TX/RX_num_unit_change Signals

Richard Tse, Microchip Technology

IEEE 802.3cx Plenary, July 21, 2021

Figure 90-1—Relationship of the TimeSync Client, TSSI and gRS sublayer relative to MAC and MAC Client and associated interfaces

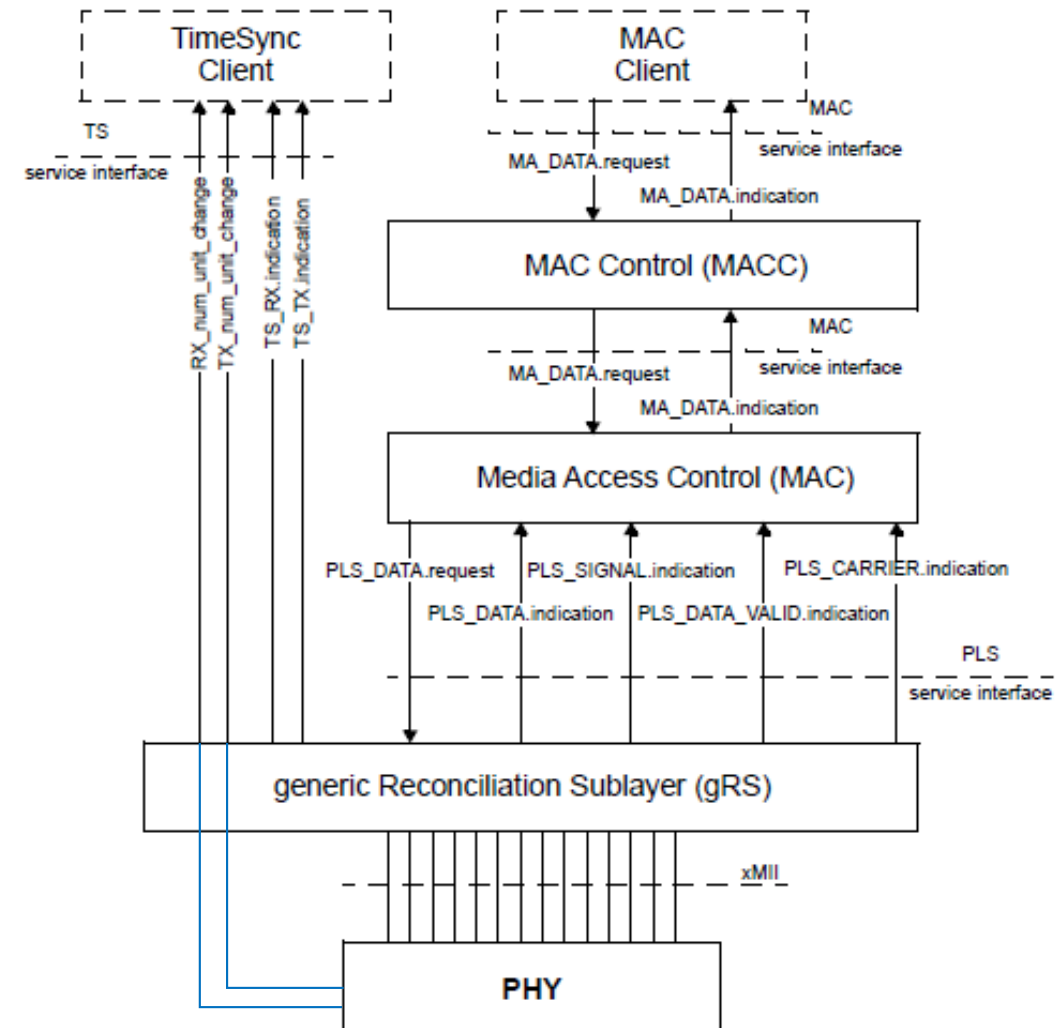
- TX/RX_num_unit_change signals are generated by the Tx/Rx PHY
 - TX/RX_num_unit_change_support register is already located alongside other PCS registers
- TX/RX_num_unit_change signals are aligned to TXD/RXD signals on the xMII
- The new lines (in blue) connecting the PHY to the gRS and TimeSync Client are shown in the updated Figure 90-1 and Figure 90-2

- Update **Figure 90-1** and **Figure 90-2** as shown earlier in this presentation
- Rename **Figure 90-2** to **Figure 90-4** (two new figures are to be inserted)
- Change **90.4.2 TSSI** as follows:

Figure 90-2—TS_MTP_Detect_TX and TS_MTP_Detect_RX functions within the generic Reconciliation Sublayer (gRS)

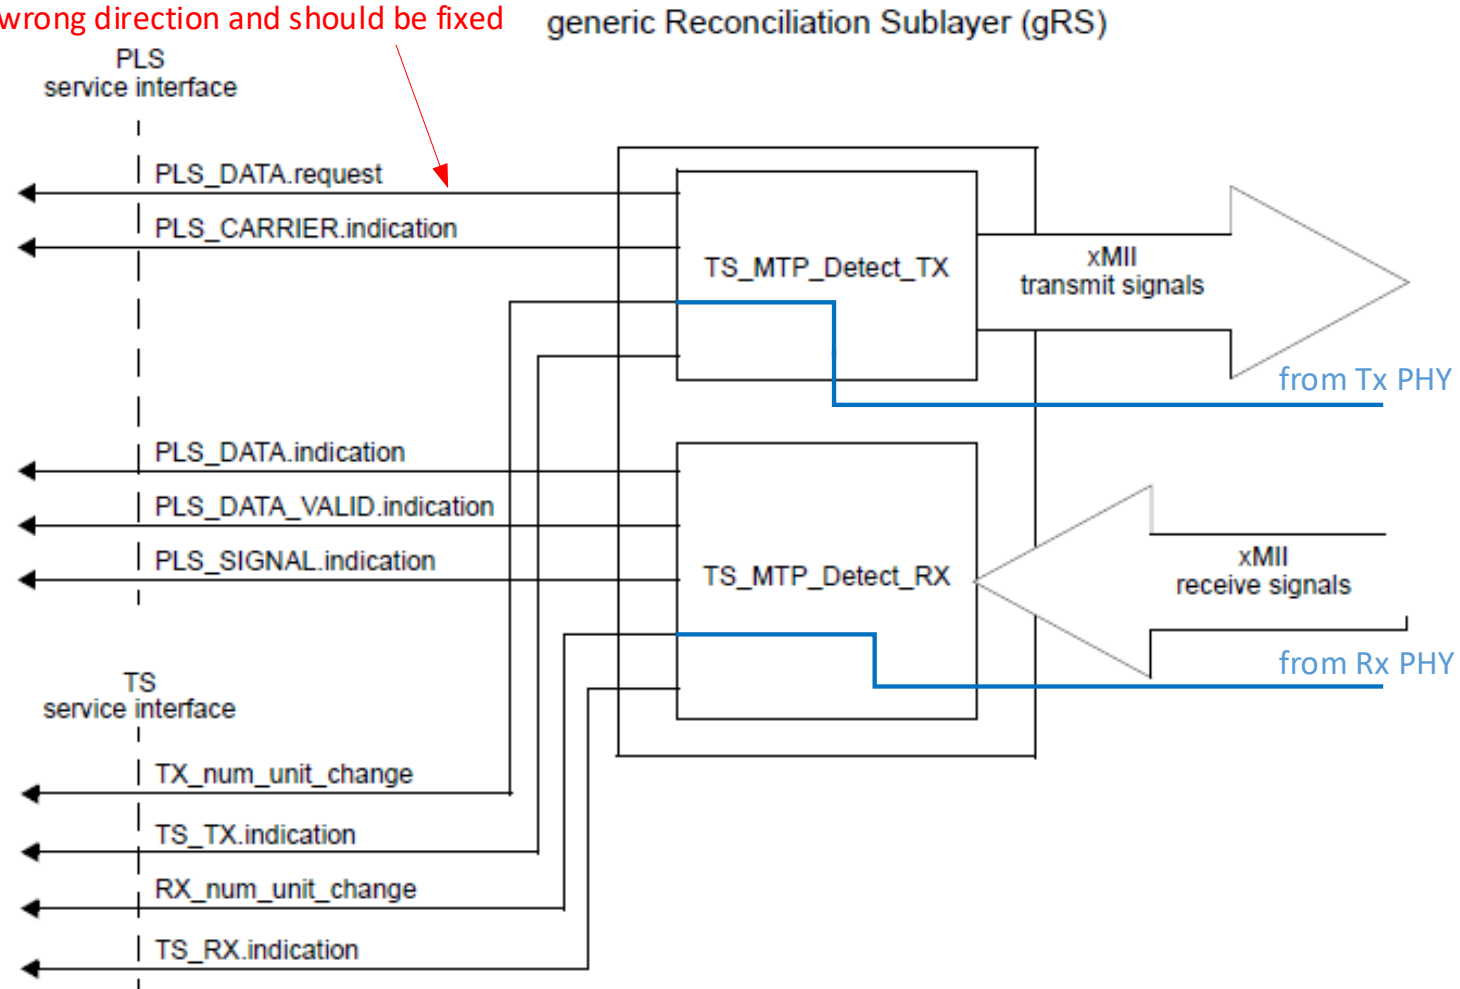
Also note that this arrow is pointing in the wrong direction and should be fixed

Figure 90-2 — Relationship between TXD and Tx_num_unit_change

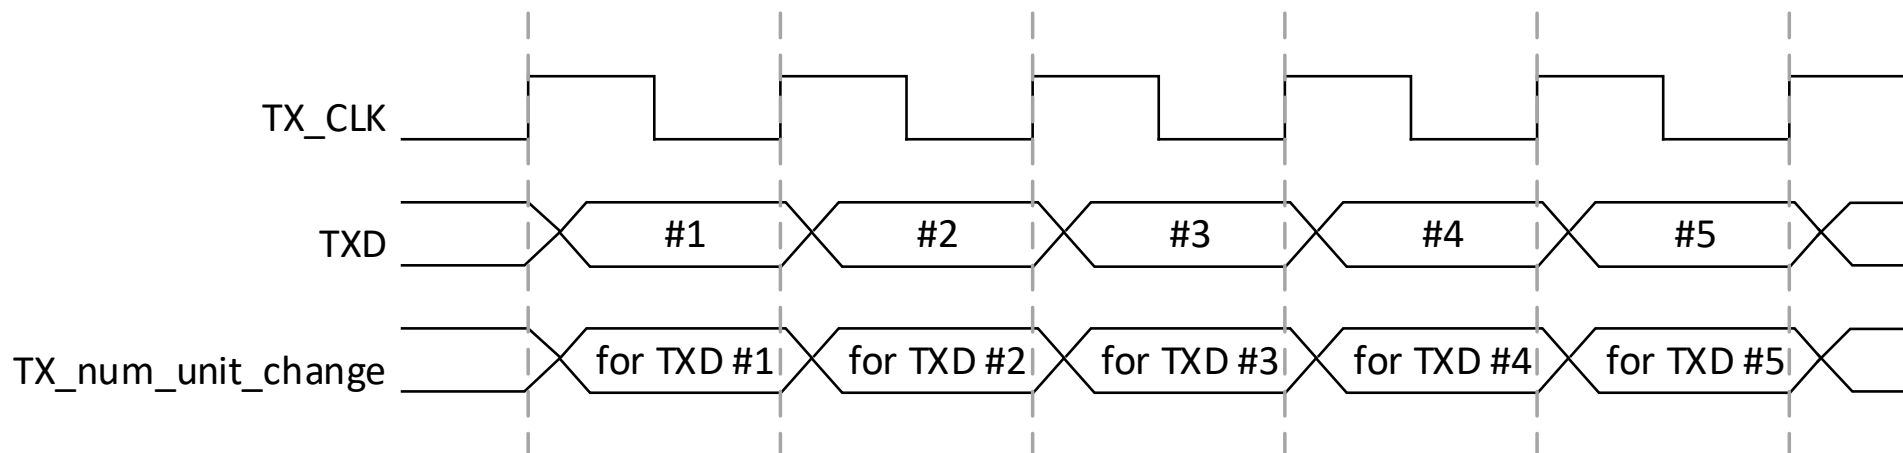
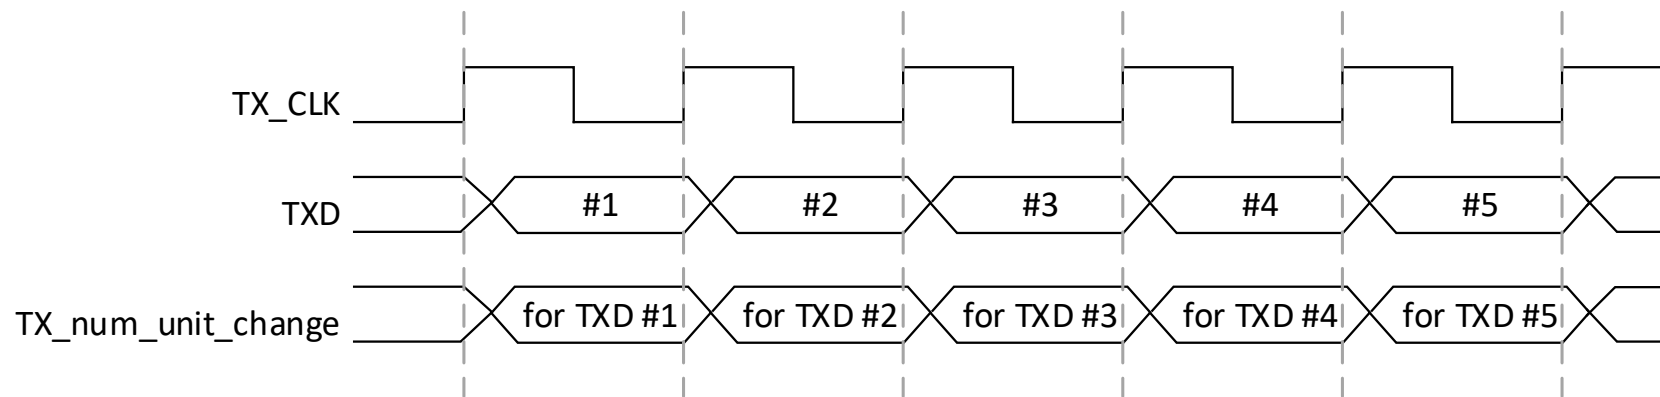
TX_num_unit_change gives advanced notification of Tx PHY path data delay changes (from upcoming AM, CWM, and Idle insertion/removal) for the TXD on the xMII

- Since AM, CWM, and Idle insertion/removal are controlled by the PHY, the PHY can generate advanced notification of these events
- TX_num_unit_change is updated by the Tx PHY on the active edge of TX_CLK before TXD is sampled by the Tx PHY

Tx_num_unit_change is generated by the Tx PHY for every Tx xMII word that it receives.

Tx_num_unit_change indicates the change in the Tx PHY's path data delay due to AM insertion, CWM insertion, and/or Idle rate adaptation insertion/removal for the corresponding Tx xMII word. If a Tx PHY does not perform these changes to its path data delay, then this primitive signal is fixed to the value zero.

Figure 90-3 — Relationship between RXD and Rx_num_unit_change

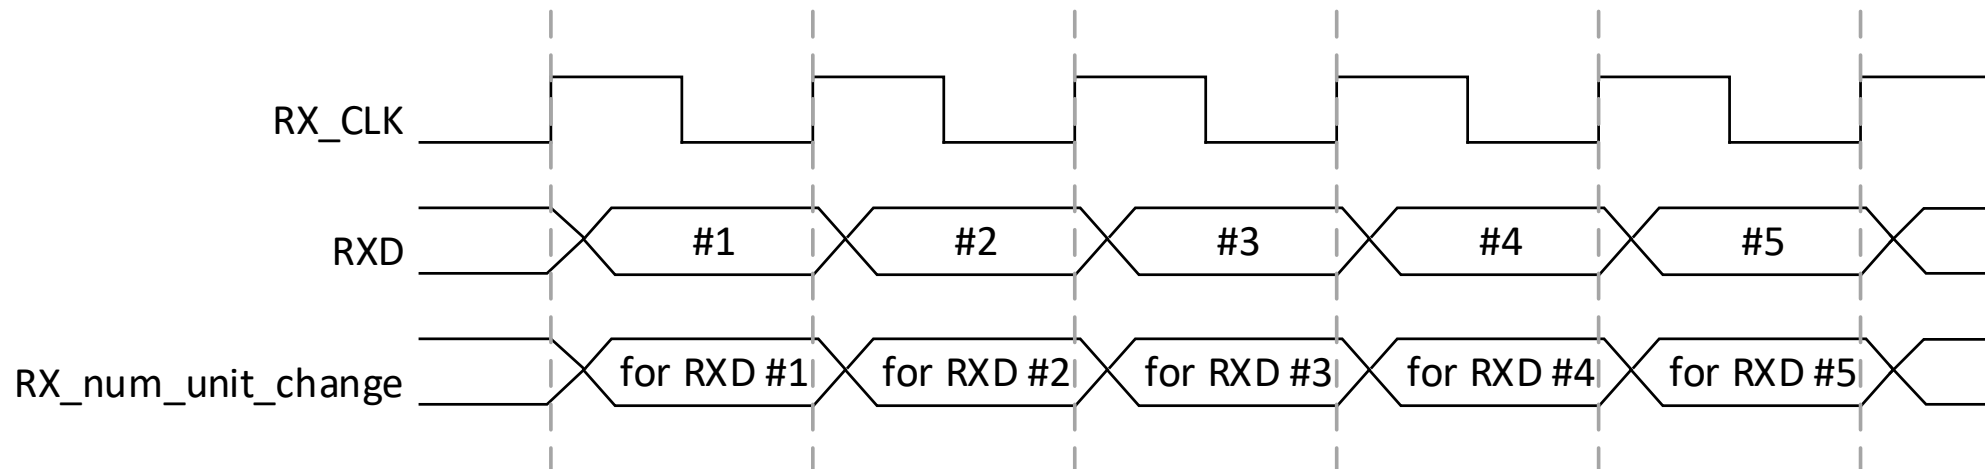
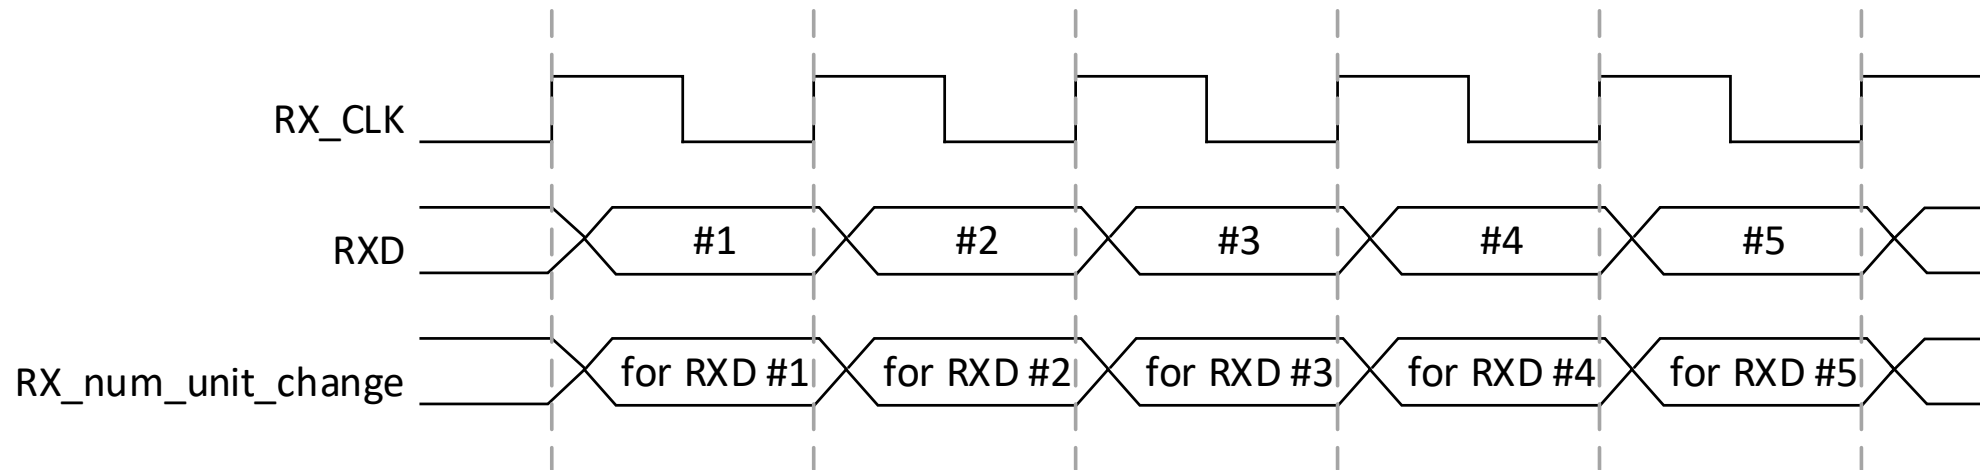
RX_num_unit_change gives the change in Rx PHY path data delay (due to AM, CWM, and Idle insertion/removal) experienced by the RXD on the xMII

- RX_num_unit_change accompanies each valid RXD on the xMII
- RX_num_unit_change is updated by the Rx PHY on the active edge of RX_CLK in the manner as RXD

Rx_num_unit_change is generated by the Rx PHY for every Rx xMII word. Rx_num_unit_change indicates the change in the Rx PHY's path data delay due to AM removal, CWM removal, and/or Idle rate adaptation insertion/removal for the corresponding Rx xMII word. If a Rx PHY does not perform these changes to its path data delay, then this ~~primitive~~signal is fixed to the value zero.
